**TRAFFIC IMPACT ASSESSMENT REPORT**  
Prepared by Bitzios Consulting Engineers

**RE: COUNCIL FURTHER ADVICE | PROPOSED RECONFIGURING A LOT AT 49 CAWDOR ROAD, HIGHFIELDS**

This letter responds to Item 5.1 to 5.3 of the FA letter.

**Figure 2.2: Crash Locations**

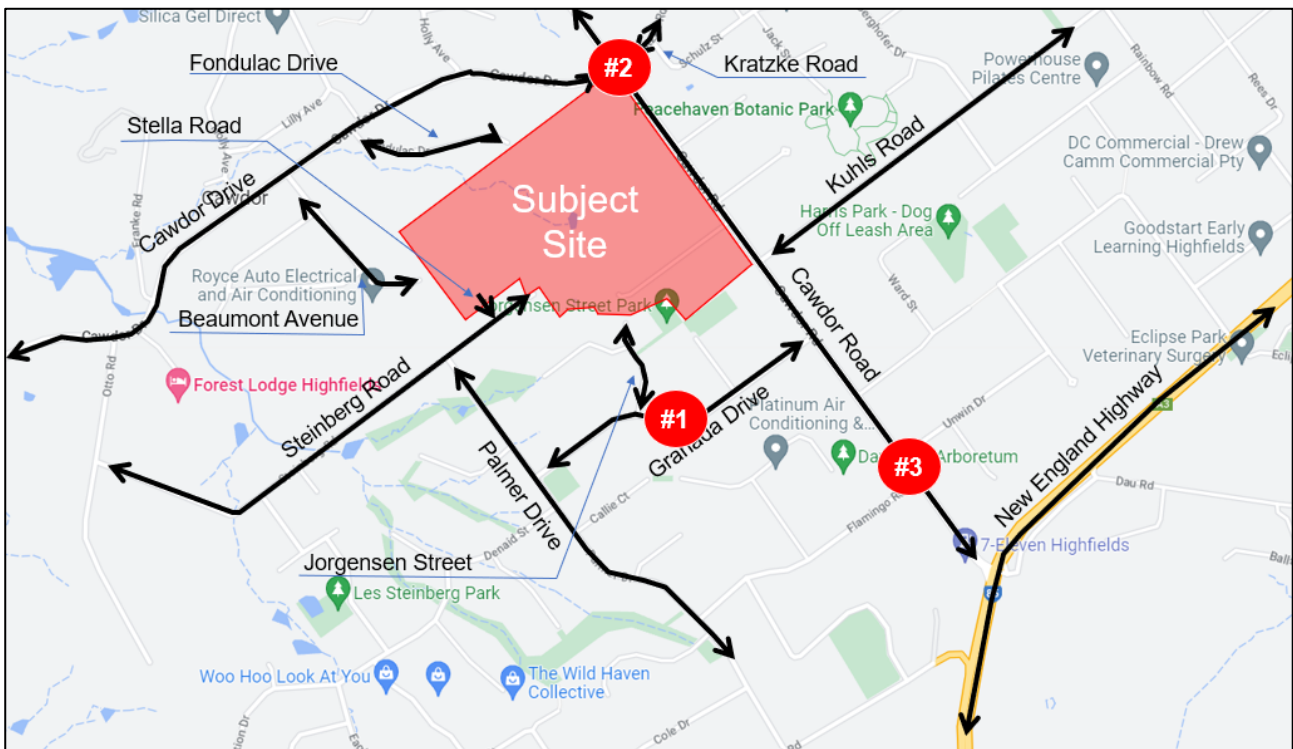
A review of the proposed development’s potential safety impacts on the local road transport network near the subject site has been undertaken in accordance with TMR’s GTIA.

Crash data for the relevant sections of nearby roads was sourced from TMR to assess crash history in the immediate vicinity of the proposed development. It is noted that KSI accidents include crashes resulting in fatality / hospitalisation.

- One (1) hospitalisation crash:
  - Crash #1: DCA Code 005 Playing, walking or lying on the carriageway occurred in 2021
- Two (2) medical treatment crashes:
  - Crash #2: DCA Code 104 Veh'S Adjacent Approach: Thru-Right occurred in 2017
  - Crash #3: DCA Code 404 Veh'S Manoeuvring: Reversing occurred in 2017

A review of the publicly available crash data suggests that noncompliance with the road rules, rather than a deficiency with the existing road network, was the largest contributing factor in the recent crashes.

The development-related safety impacts on the subject intersection have been assessed. The safety risks identified at the subject intersection have been assessed as summarised in Table 2.1.

The development-generated traffic is not anticipated to increase any of the risk scores associated with the risk items identified. Therefore, no safety mitigation measures are warranted.
